Technical Service Information

FORD AXOD NEW SCREEN IN CASE

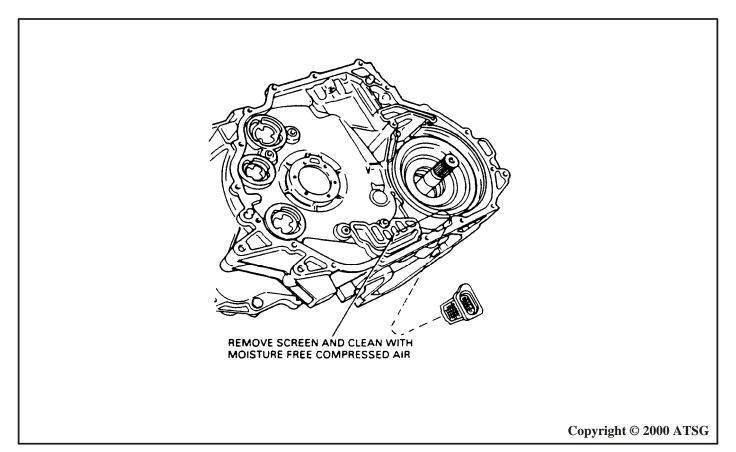
CHANGE: A new filter has been added to the 1989 AXOD 1-2 servo apply circuit (See Figure 1).

REASON: The filter prevents large metal chips from entering the valve body.

- (1) CHAIN COVER 1-2 servo passage changed to accommodate the new screen,
- (2) TRANSAXLE CASE 1-2 servo passage changed to accommodate the new screen.

The new screen WILL NOT retro fit to previous models. The 1-2 servo passage on the previous models chain cover will not accommodate the new screen and an interference will occur. NOTE: A no forward condition could occur if the filter becomes contaminated.
